## Meeting Agenda Planning Commission

## Staff Report

GLUA-19-00006 (General Land Use Application), SP-19-00025 (Site Plan and Design Review), and VAR-19-00001 (Variance)

### TYPE III –SITE PLAN AND DESIGN REVIEW AND VARIANCE STAFF REPORT AND RECOMMENDATION

Figure 5: Proposed Building Elevations

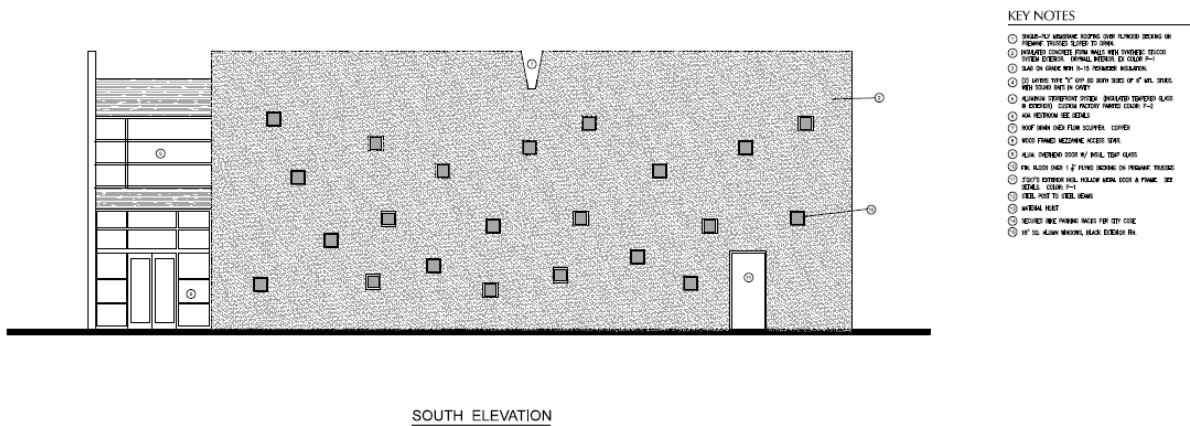
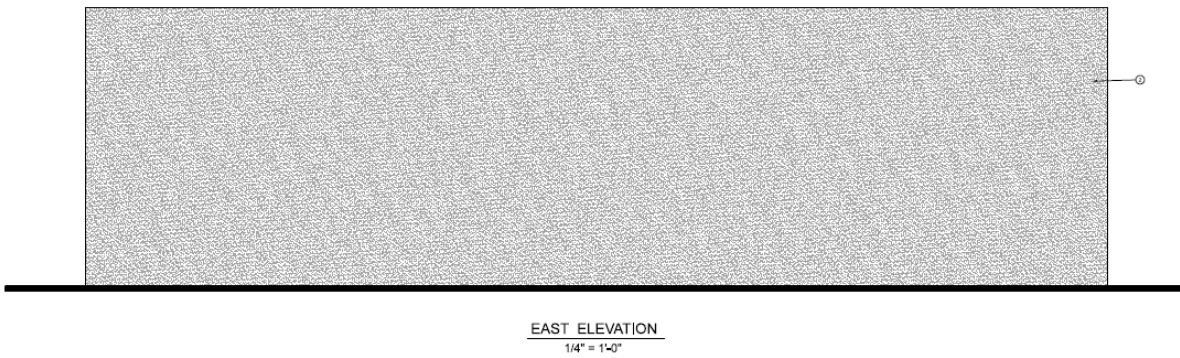
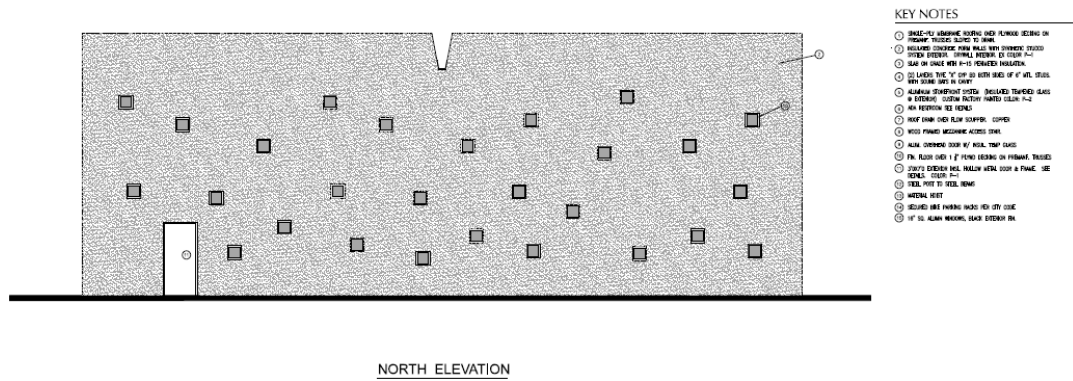
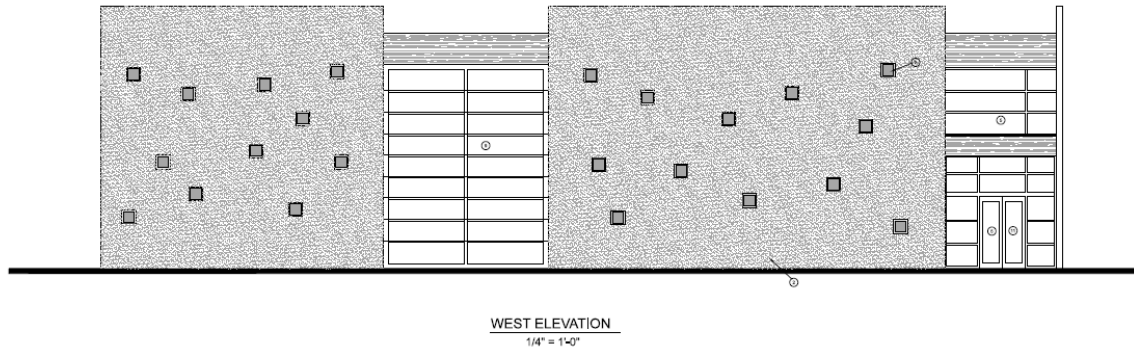
**Finding: Complies as Proposed.** The applicant has requested a modification to the special materials standards for stucco and Exterior Insulation and Finish System (EIFS), which require that stucco is trimmed in wood or masonry and is sheltered from extreme weather by roof overhangs or other methods. The applicant has proposed a synthetic stucco, which is similar to stucco or Exterior Insulation and Finish System (EIFS) material with no trim or overhang.

Figure 6: Landscaping Plan

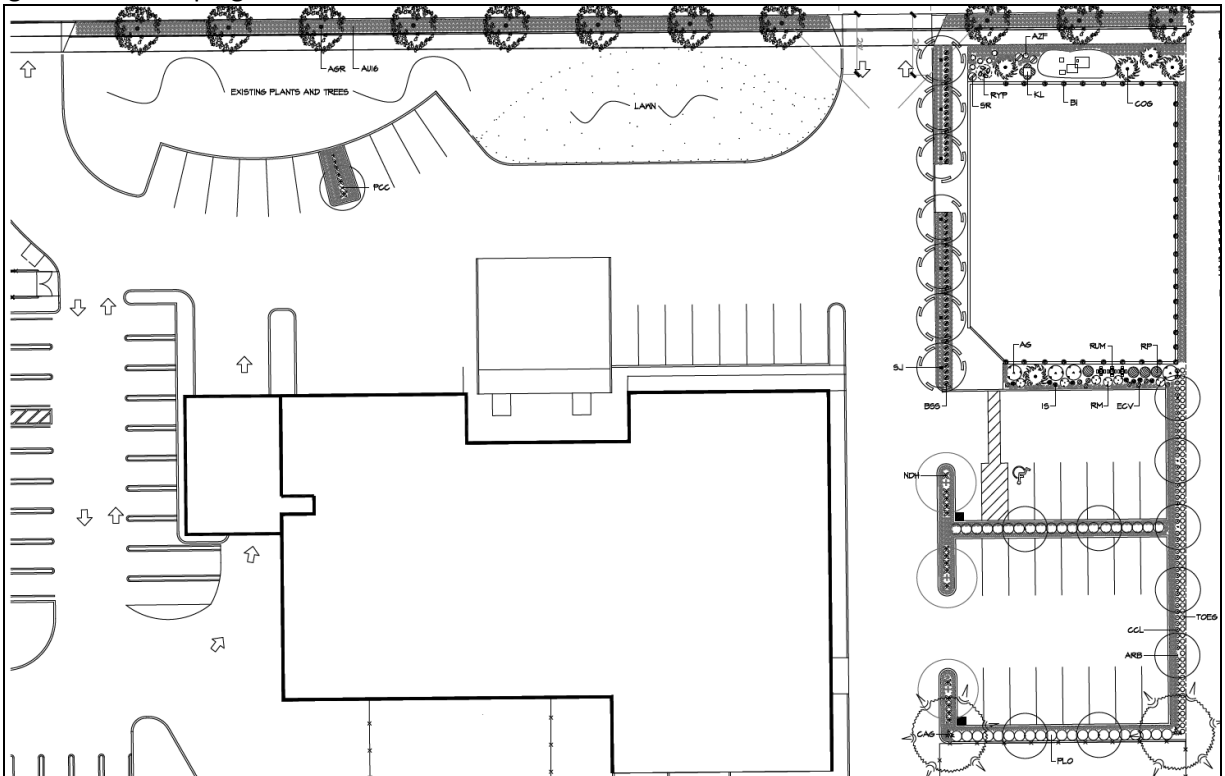
**Finding: Complies as Proposed.** The existing and proposed landscaping is located in defined landscaped areas that are distributed throughout the parking lot.

16. The applicant shall submit a revised landscaping plan: (P)
  - a. Identifying that within three years of planting, landscaping will cover one hundred percent of newly landscaped areas, including perimeter parking lot landscaping, building buffer landscaping, interior parking lot landscaping, and overall site landscaping.
